**URGENT - FIELD SAFETY NOTICE**

**MAQUET VOLISTA  
Field Action *MSA/2017/006/IU***

| <b>Product Issue:</b>        | Detachment of the central handle holder from the VOLISTA surgical light  |

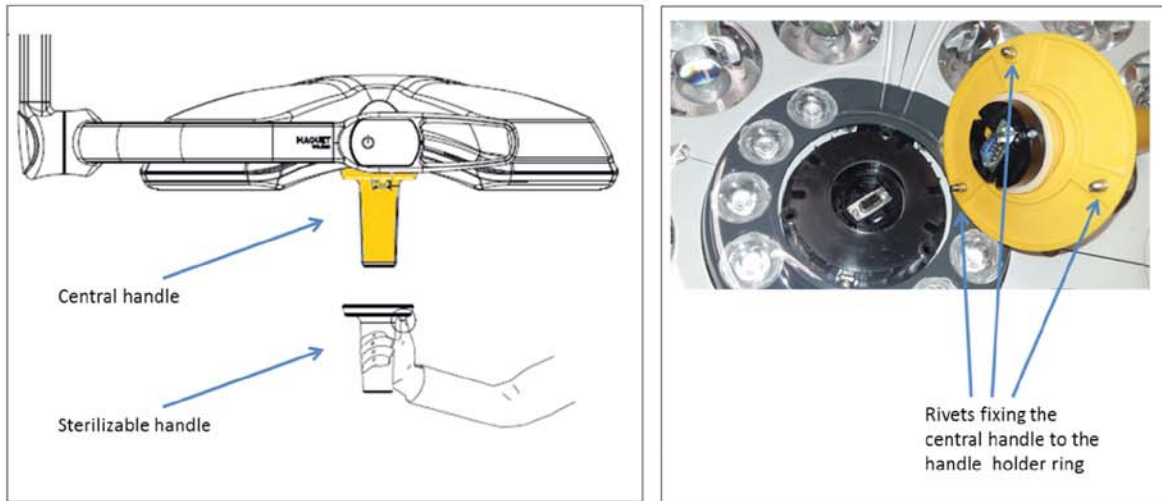
We received complaints indicating that the central handle holder detaches easily from the cupola during use. We determined that the root cause of this malfunction is excessive tightening of the screws during mounting of the handle holder, resulting in the rivets loosening and detaching from the central handle holder ring.

During manipulation, the handle holder may completely detach from the light head, if all three rivets loosen simultaneously. In this case, although the handle remains in the user's hand, small quantities of particles may be generated from the plastic holder ring. From our clinical evaluation, it was concluded that there is a remote chance that this issue may cause post-operative infection, foreign body granuloma or allergic reactions, if the particles fall into the patient's wound or on sterile equipment.

The issue was solved in production by a design change of the rivets (modification of shape and overmolding with the handle holder ring). For units manufactured before application of the modification in production, we see the issue as a potential long term hazard and want to prevent any related event from occurring with our customers. This action consists in the replacement of the existing central holder rings with the new design.

| <b>Resolution:</b>           | Maquet proposes to replace the central holder ring of your VOLISTA surgical light to make sure all devices present in the market are working effectively and safely. |

This letter is to inform you of a corrective action that will be performed on these units to prevent a possible hazard to persons and equipment. This action consists in the replacement of the central handle holder ring.
